PRODUCT / PROCESS CHANGE NOTIFICATION

1.1 Company		STMicroelectronics International N.V
1.2 PCN No.		ADG/22/13415
1.3 Title of PCN		IPAK Cu wire line relocation from Shenzhen to Tongfu Microelectronics (China)
1.4 Product Category		Power MOSFET HV
1.5 Issue date		2022-05-03

Comparison IPAK Shenzhen vs TFME

IPAK Cu wire line relocation from Shenzhen to Tongfu Microelectronics (China)

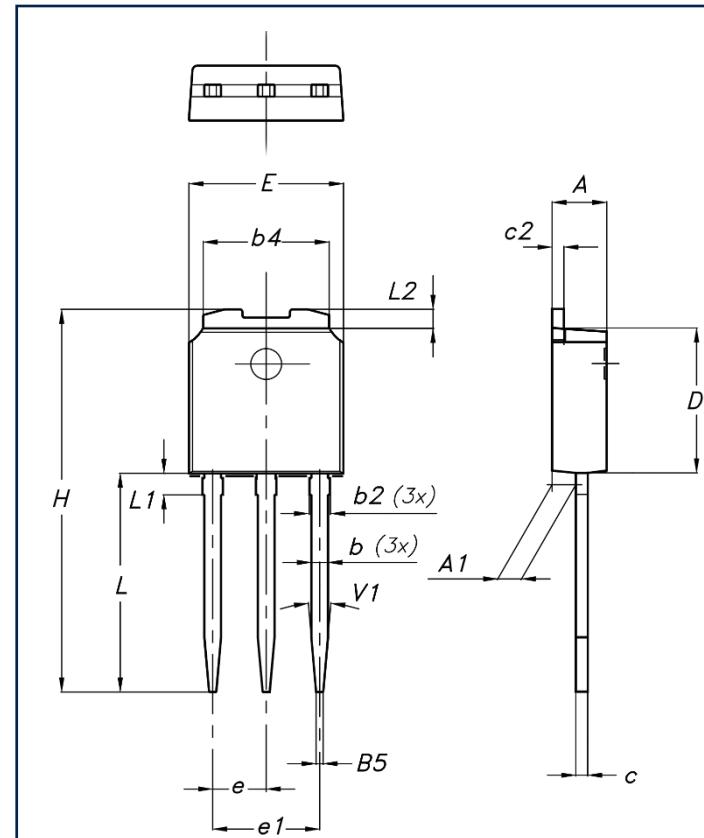
Shenzhen (type A)

Dim.	mm			Dim.	mm		
	Min.	Typ.	Max.		Min.	Typ.	Max.
A	2.20		2.40	A	2.20	2.30	2.35
A1	0.90		1.10	A1	0.90	1.00	1.10
b	0.64		0.90	b	0.66		0.79
b2			0.95	b2			0.90
b4	5.20		5.40	b4	5.23	5.33	5.43
B5		0.30					
c	0.45		0.60	c	0.46		0.59
c2	0.48		0.60	c2	0.46		0.59
D	6.00		6.20	D	6.00	6.10	6.20
				D1	5.20	5.37	5.55
E	6.40		6.60	E	6.50	6.60	6.70
				E1	4.60	4.78	4.95
e		2.28		e	2.20	2.25	2.30
e1	4.40		4.60	e1	4.40	4.50	4.60
H		16.10		H	16.18	16.48	16.78
L	9.00		9.40	L	9.00	9.30	9.60
L1	0.80		1.20	L1	0.80	1.00	1.20
L2		0.80	1.00	L2	0.90	1.08	1.25
V1		10°		θ1	3°	5°	7°
				θ2	1°	3°	5°

TFME (type C)

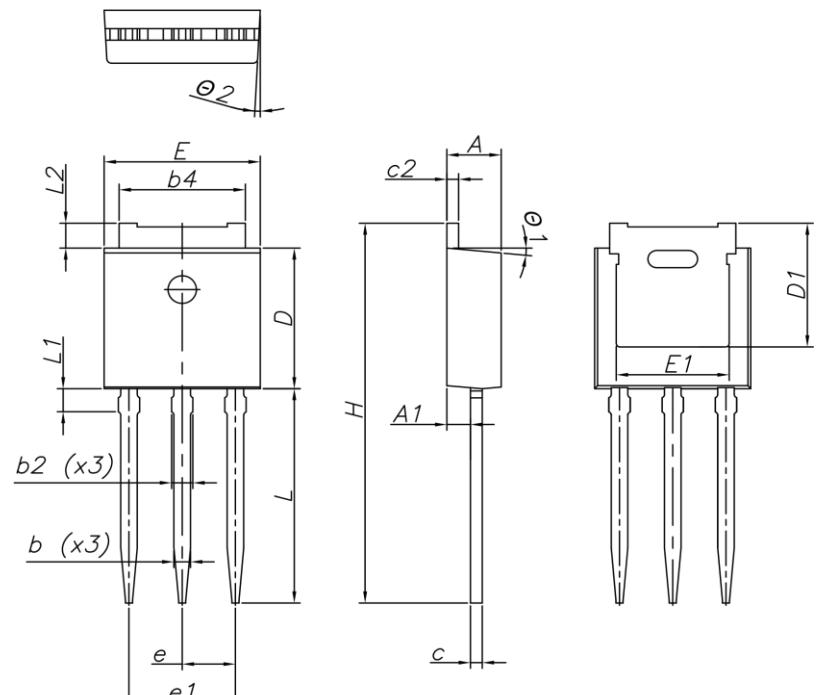
Shenzhen

TFME
